# Access Compliance Report

## Public Rights-of-Way

### (Curb Ramps)

Intersection ID: 50512	Main Street: EVERSFIELD_LN	Cross Street: MERIDALE_CROSSING_DR	Location: E
ADA ID: 6A4C331DF6AC	Ramp Type: PerpDiag	Initial Pass/Fail: Fail	Overall Compliance: No
Severity Score: 25			
Codes/Mitigation Info/Possible Solution		Field Measurements/Component Compliance

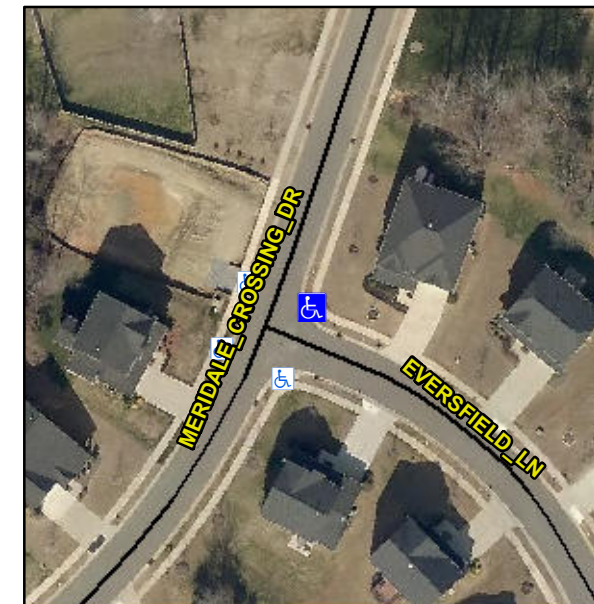
**R304.2.2, R304.5.3**

Compliance	Description	Data	Compliance	Description	Data
N/A	Ramp Length (in)	49.0	No	Ramp Slope (%)	8.9
Yes	Ramp Width (in)	48.0	No	Ramp XSlope (%)	5.2
N/A	Flare Type LT	N/A	N/A	Flare Type RT	N/A
N/A	Flare Slope LT (%)	N/A	N/A	Flare Slope RT (%)	N/A
N/A	Flare Traversable LT?	N/A	N/A	Flare Traversable RT?	N/A
N/A	Landing Length (in)	N/A	N/A	DWS Provided?	N/A
N/A	Landing Width (in)	N/A	N/A	DWS Contrast?	N/A
N/A	Landing Slope (%)	N/A	N/A	DWS Length (in)	N/A
N/A	Landing X Slope (%)	N/A	N/A	DWS Full Width?	N/A
N/A	Landing Curb? (Y/N)	N/A	N/A	DWS Offset (in)	N/A
N/A	Shared Landing?	N/A			
N/A	Gutter Ponding?	N/A	N/A	Gutter Slope (%)	N/A
N/A	Gutter Lip Ht (in)	N/A	N/A	Gutter X Slope (%)	N/A
N/A	Painted X Walk1?	No	N/A	Painted X Walk2?	No
	X Walk 1 Direction	To NW		X Walk 2 Direction	To SW
N/A	X Walk 1 Width (in)	N/A	N/A	X Walk 2 Width (in)	N/A
	X Walk 1 Slope (%)	0.8		X Walk 2 Slope (%)	1.1
	X Walk 1 X Slope (%)	4.8		X Walk 2 X Slope (%)	2.5

N/A	Ramp inside XWalk1?	N/A	N/A	Ramp inside XWalk2?	N/A
	Road Slope (%)	4.6	N/A	Clear Space?	N/A
	Road X Slope (%)	0.9	N/A	Clear Space to XWalk (in)	N/A
N/A	Any Obstructions?	N/A	N/A	Storm Grate/Utility Hazard?	N/A
	Obstruction Type			Storm Grate/Utility Type	
		N/A			N/A
			Yes	Surface Condition? (G/P)	Good

**Remove & Replace Curb Ramp With Two New Directional Ramps or Equivalent.**
